**Texas Department of Transportation
Book 2 - Technical Provisions**

**North Tarrant Express Project
Segments 3A and 3B Facility**

**Attachment 11-1
Approved Design Deviations**

September 30, 2012

NTE MDP CDA
SEGMENT 3B
EXHIBIT 2
RESPONSE TO RFI NO. 26
Sheet 1 of 2

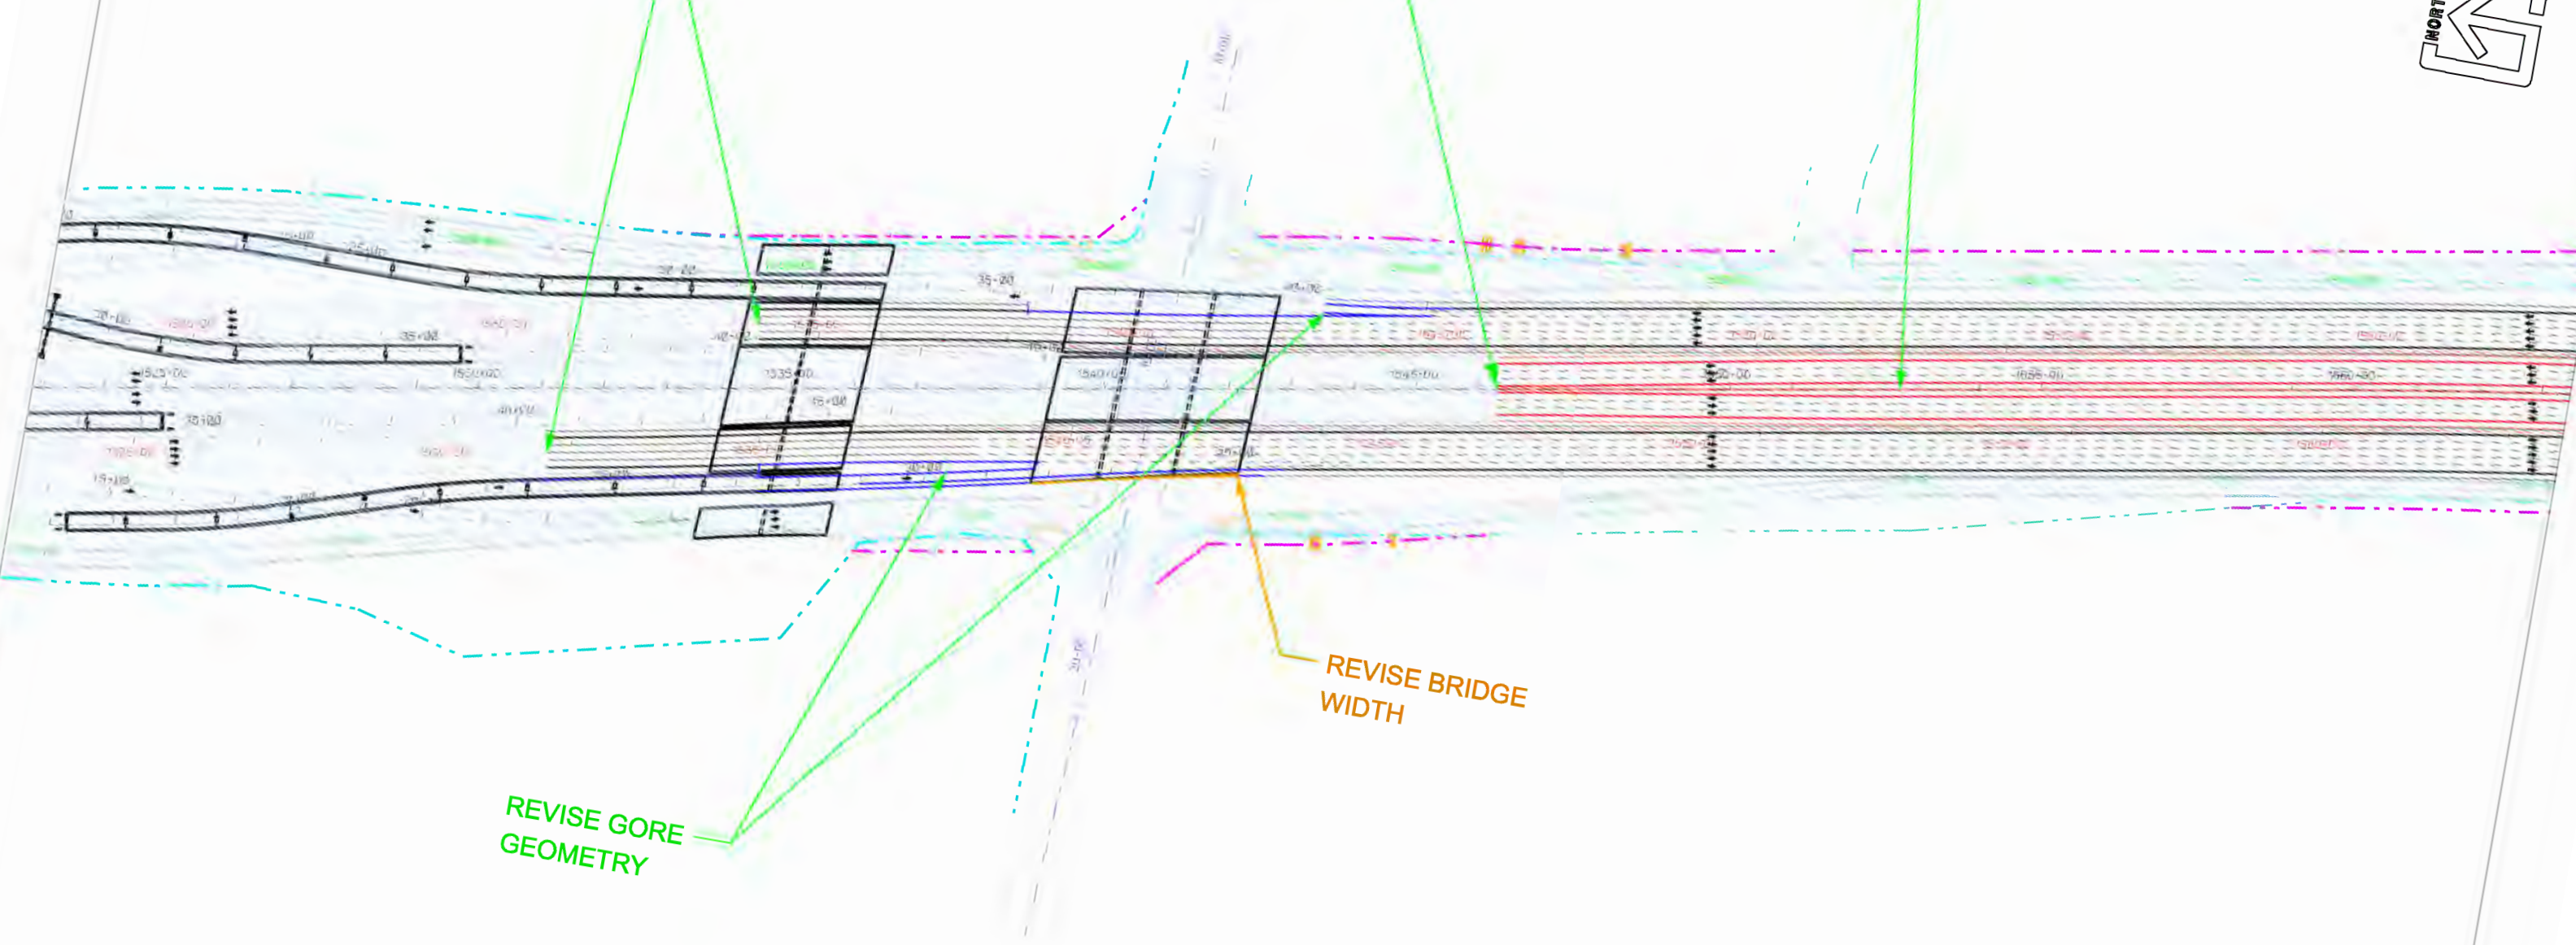
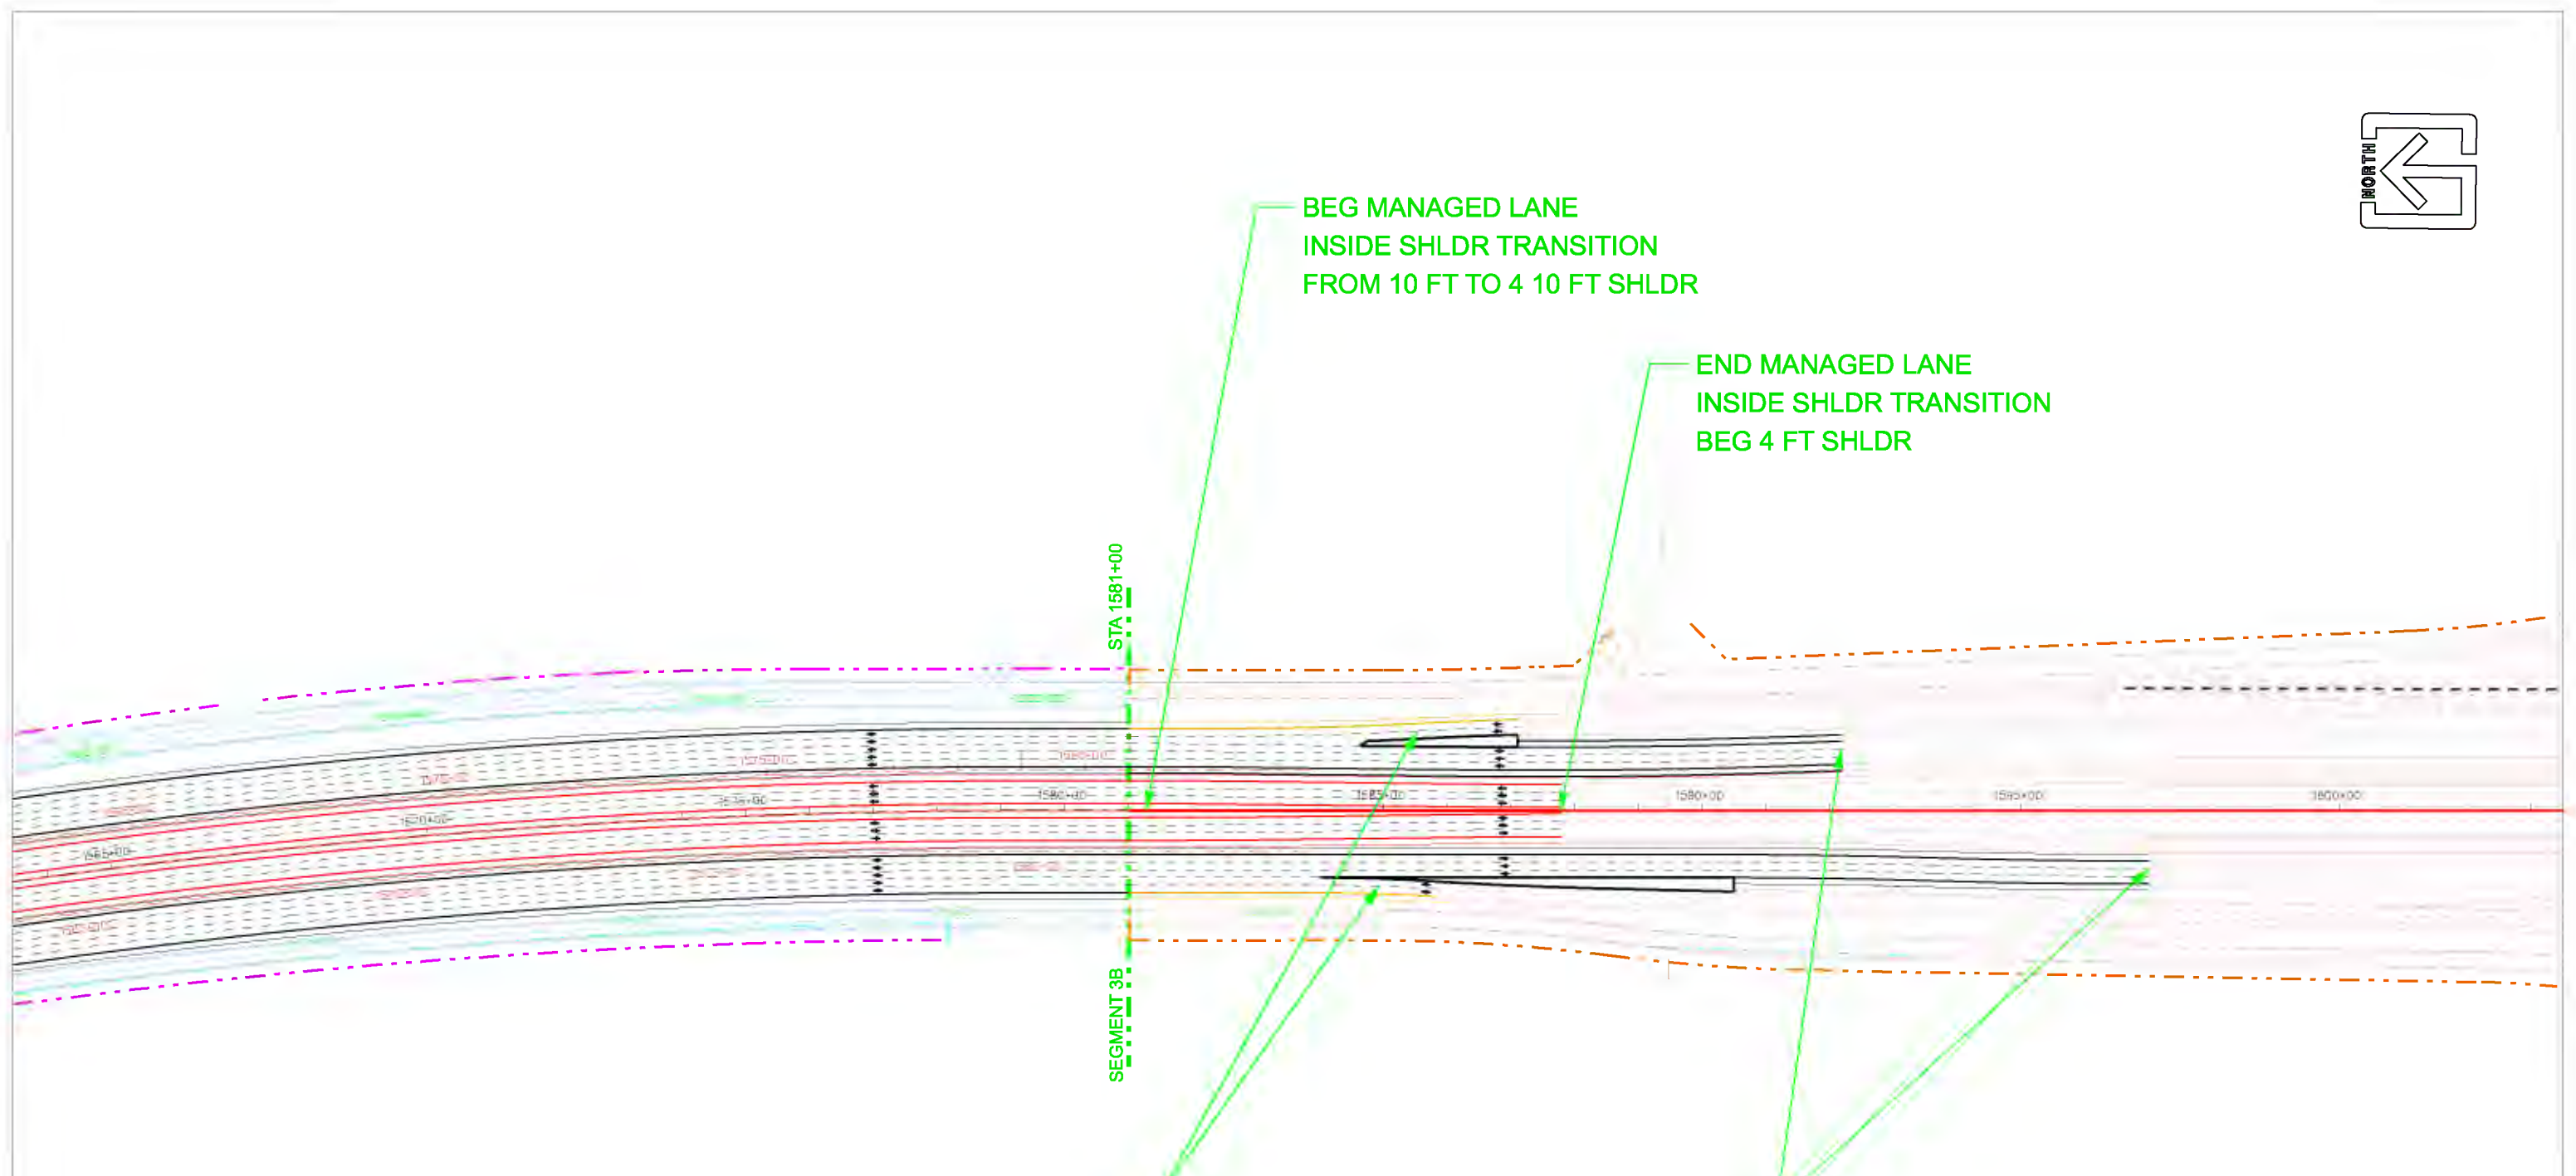
REVISE GORE
GEOMETRY

REVISE BRIDGE
WIDTH

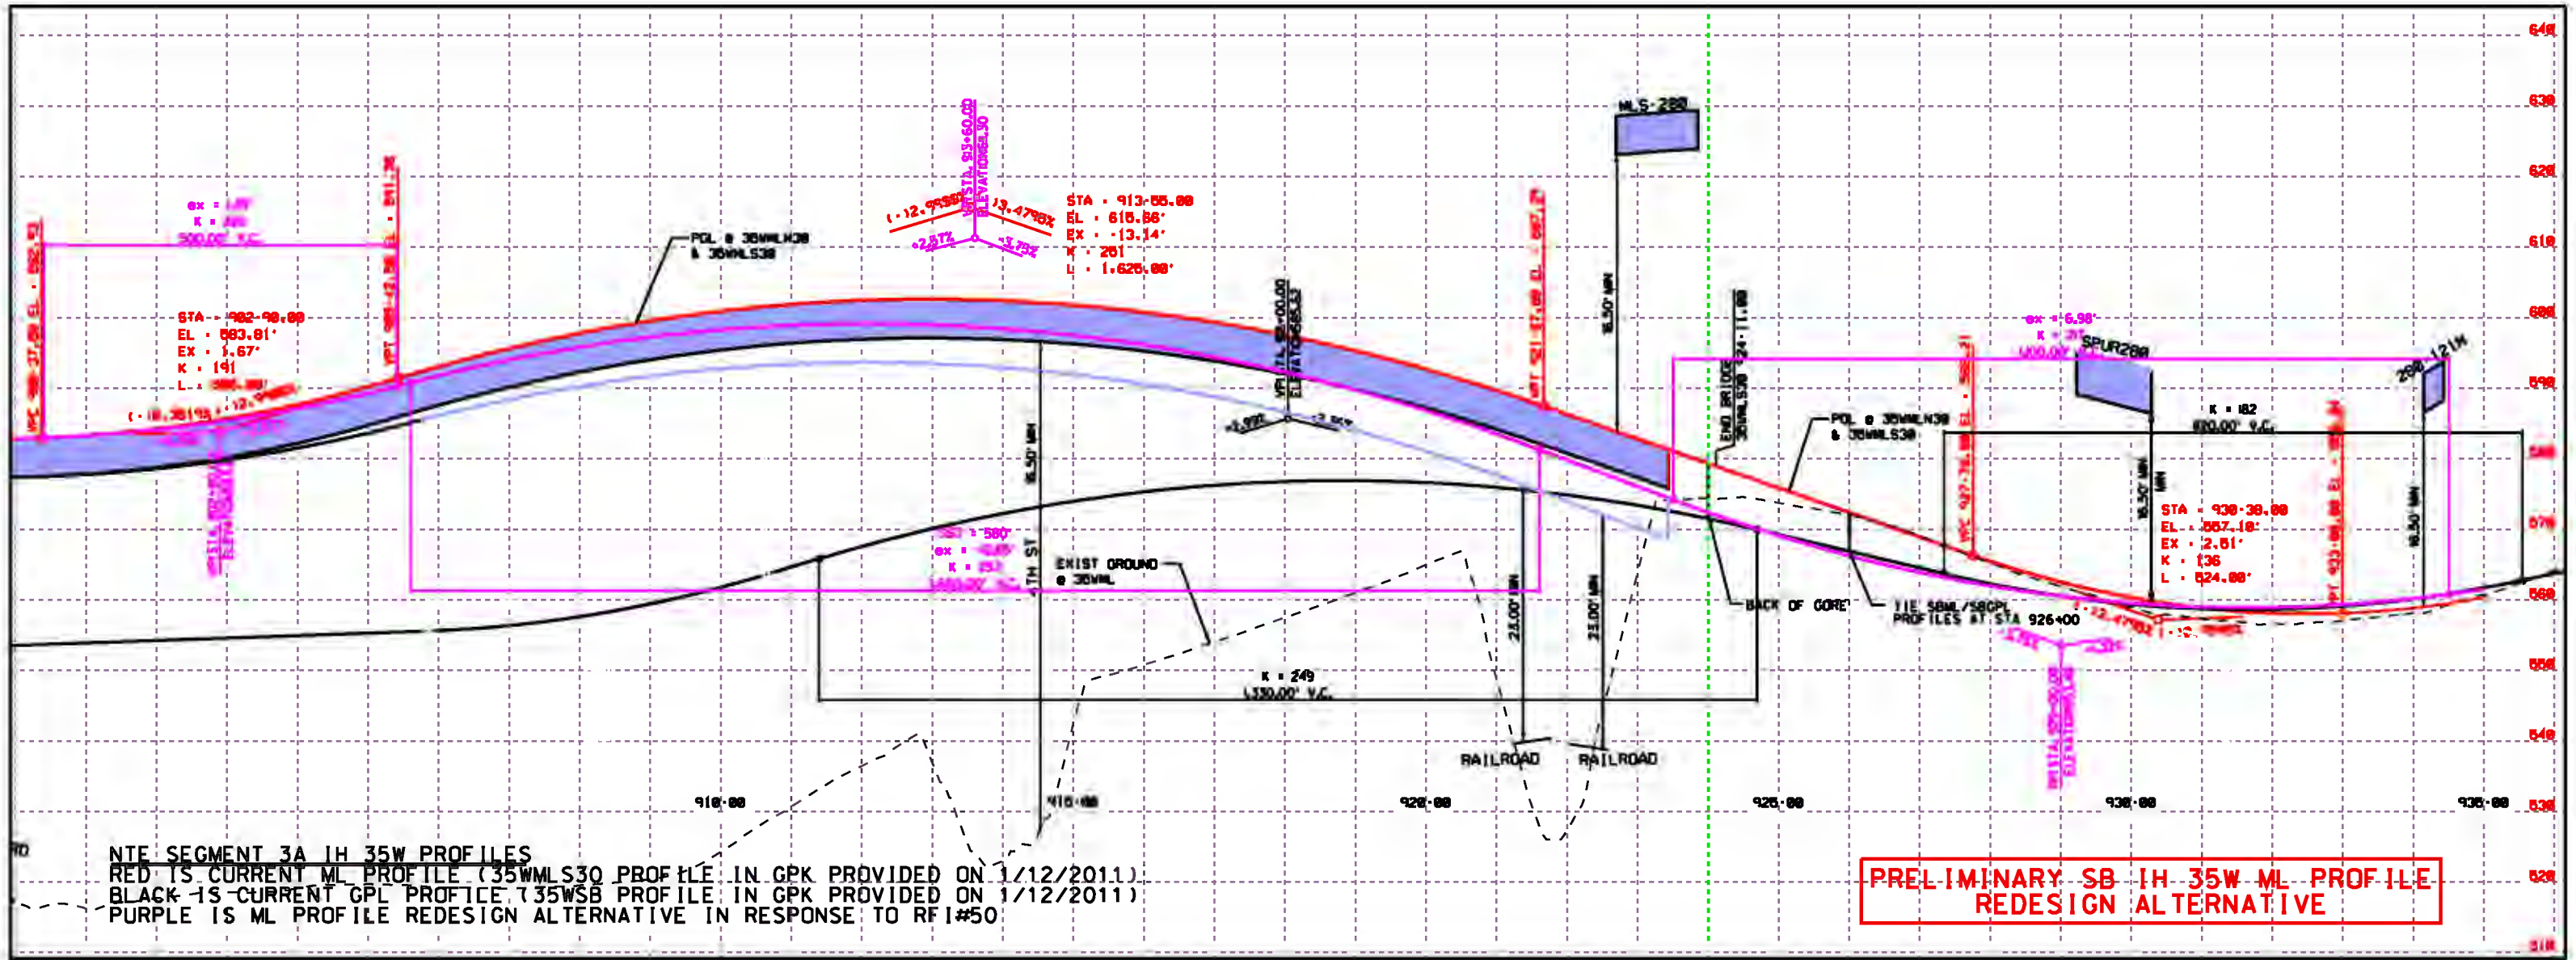
TxDOT understands that the current SB Managed Lane vertical alignment (35WMLS30) south of STA 913+55 does not meet the maximum grade requirement of 3% for 70 mph as specified in Book 2 (currently 3.48%). TxDOT also understands that the SB Managed Lane vertical alignment where it ties to the SB General Purpose Lanes is incompatible with the horizontal geometry contemplated for the ultimate configuration just south of the RR bridge. The current 35WMLS30 vertical alignment is apparently compatible with the interim SB General Purpose Lane horizontal and vertical alignments.

The SB Managed Lane vertical alignment south of STA 913+55 appears higher than required to tie to the ultimate SB General Purpose Lanes just south of the RR. TxDOT would like to suggest an alternative solution for NTEMP's consideration. The solution consists of lowering the Managed Lane vertical alignment and the interim SB General Purpose Lane vertical alignment between STA 913+55 and Spur 280 as shown in Exhibit 1. The alternative includes lowering the vertical alignment of the 35WMLS30 by approximately 7' at the south end of the RR bridge using a maximum grade of 4% and a design speed of 70mph while maintaining the required clearance over the RR (calculated clearance of 33'). The interim SB General Purpose Lanes would also be lowered to accommodate the ultimate horizontal and vertical geometry. Minor adjustments south of STA 913+55 would be required to the NB Managed Lanes vertical alignment, the SB Managed Lane exit ramp to US 287 and interim exit ramp to Spur 280.
